*Finding of No  
Significant Impact*

**STPP 69-1(9)22**

*Boulder-South*

Jefferson County, Montana

Figure 2-1 Existing and Proposed Cross Sections

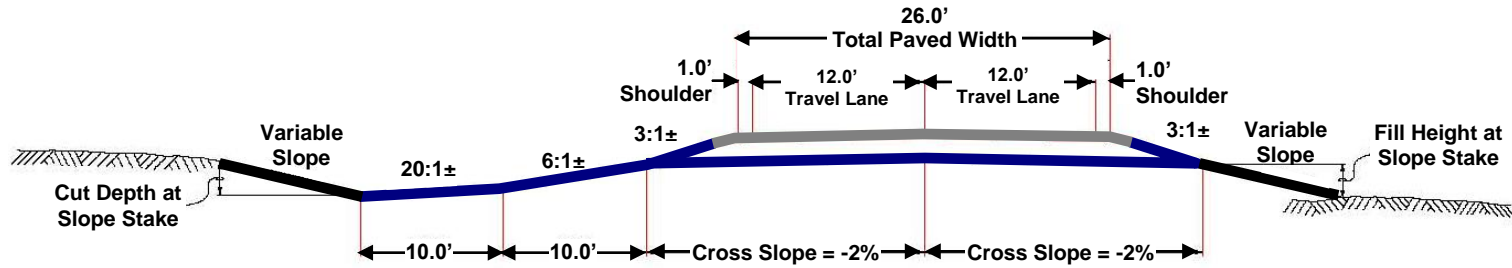
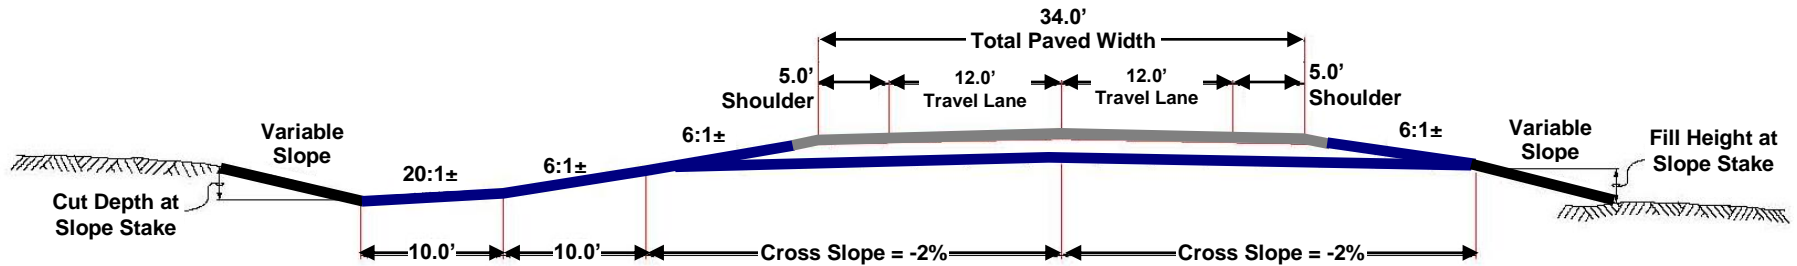
<u>Location</u>	<u>Action</u>	<u>Edit</u>
Page 7, Figure 2-1	Clarification	The Existing Cross Section presented in Figure 2-1 represents the best case condition. In many locations within the corridor, side slopes are steeper and shoulders are narrower than shown in Figure 2-1. An example is provided below where the existing roadway does not include a one-foot shoulder or 3:1 side slopes on both sides of the roadway.

Figure 2-2 Pedestrian/Bicycle Facility Design Options

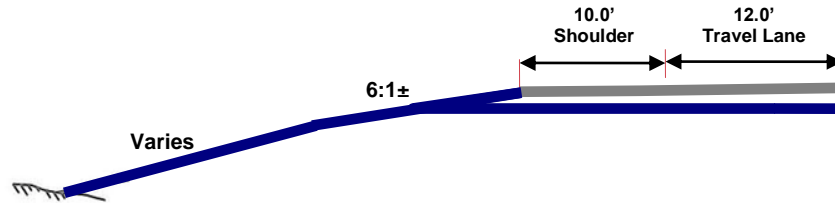
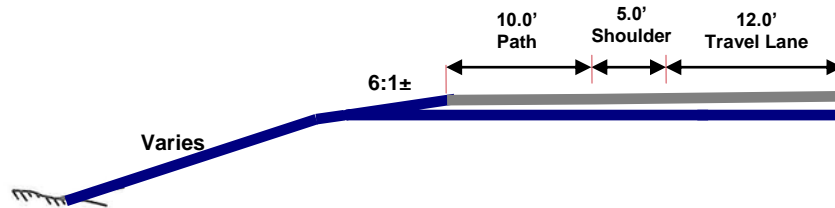
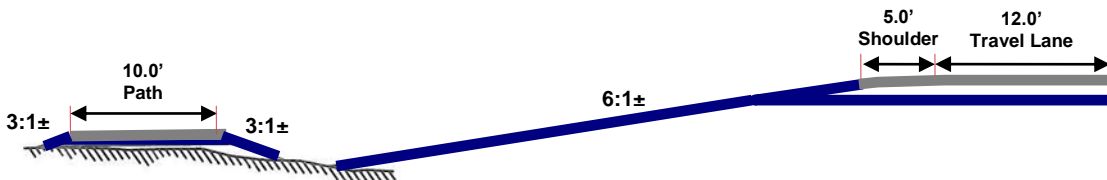
- 5-c** The only down side i see with having the road widened is the possibility of more truck traffic. The last road rutted out and caused many hydroplaning accidents. The ruts were for sure caused by the heavy load of truck traffic.

4-b Figure 2-2 (page 8 of the EA) presents pedestrian/bicycle facility design options that are under consideration as part of this project. MDT is working with Jefferson County, the City of Boulder, and local pedestrian/bicycle groups to identify the best facility option, the appropriate extents of a facility, and possible funding and maintenance arrangements.

Given the large volume of public comments requesting consideration of a bicycle / pedestrian facility, MDT will consider this element as part of the Boulder – South project. Figure 2-2 (page 8 of the EA) presents pedestrian/bicycle facility design options that are under consideration as part of this project. MDT is working with Jefferson County, the City of Boulder, and local pedestrian/bicycle groups to identify the best facility option, the appropriate extents of a facility, and possible funding and maintenance arrangements.

Figure 2-2 (page 8 of the EA) presents pedestrian/bicycle facility design options that are under consideration as part of this project. MDT is working with Jefferson County, the City of Boulder, and local pedestrian/bicycle groups to identify the best facility option, the appropriate extents of a facility, appropriate crosswalk locations, and possible funding and maintenance arrangements.
